H. B. ROBINSON STEAM ELECTRIC PLANT, UNIT NO. 2
DOCKET NO. 50-261/RENEWED LICENSE NO. DPR-23

Subject: Completion of Required Actions for NRC Order EA-12-051 With Regard to Reliable Spent Fuel Pool Level Instrumentation

**DUKE ENERGY'S RESPONSE TO
SPENT FUEL POOL LEVEL INSTRUMENTATION (SFPLI) REQUEST FOR
ADDITIONAL INFORMATION (RAI's) AND SAFETY EVALUATION
REVIEW ITEM #7**

Sensing Line Channel 1

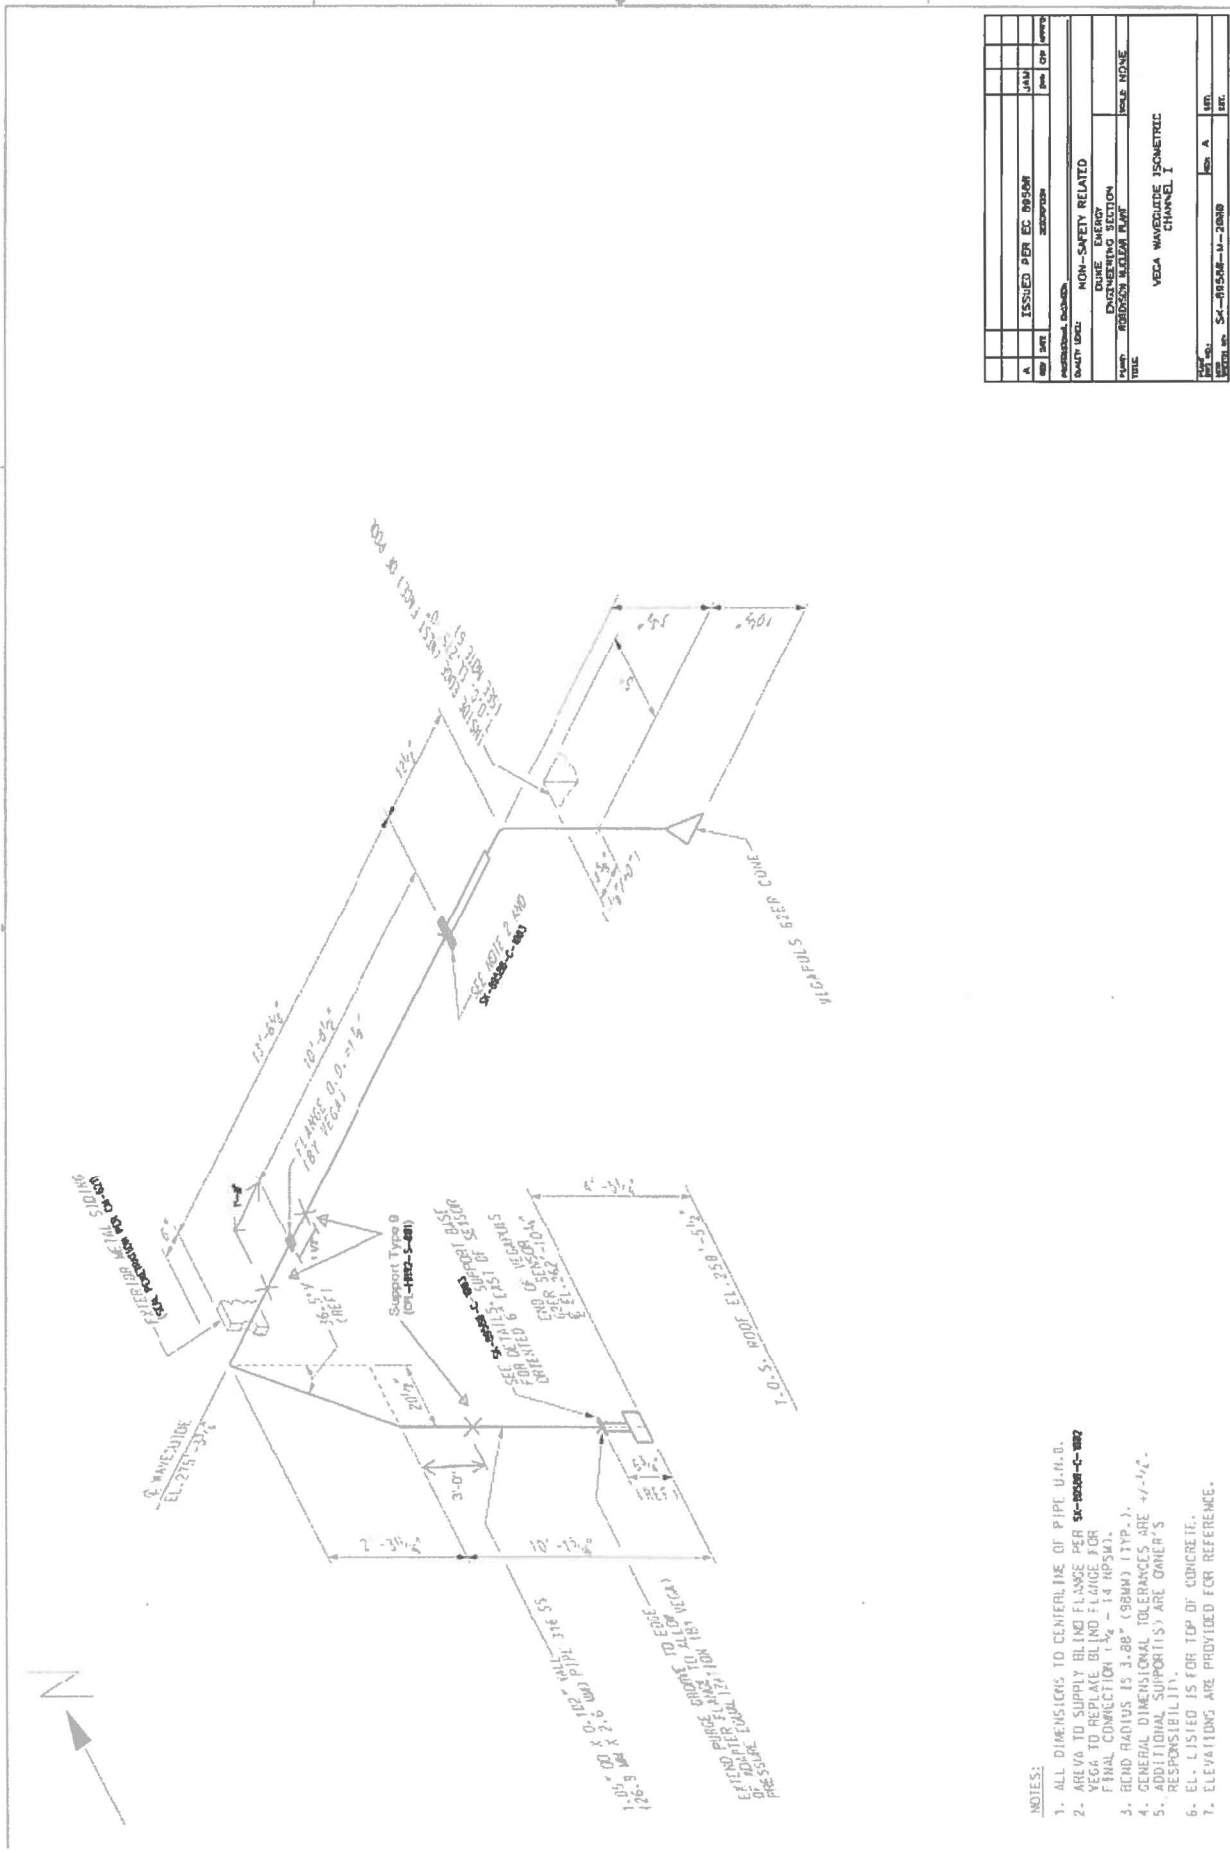
- The design criteria that will be used to estimate the total loading on the mounting device(s), including static weight loads and dynamic loads. Describe the methodology that will be used to estimate the total loading, inclusive of design basis maximum seismic loads and the hydrodynamic loads that could result from pool sloshing or other effects that could accompany such seismic forces.

- A description of the manner in which the level sensor (and stilling well, if appropriate) will be attached to the refueling floor and/or other support structures for each planned point of attachment of the probe assembly. Indicate in a schematic the portions of the level sensor that will serve as points of attachment for mechanical/mounting or electrical connections.

- A description of the manner by which the mechanical connections will attach the level instrument to permanent SFP structures so as to support the level sensor assembly.

The routing for this line is shown on Sketch SK-89580-M-2000 and is different from that of sensing line Channel 2. The span inside the fuel handling building is long and needs a support inside the building and is evaluated as discussed below.
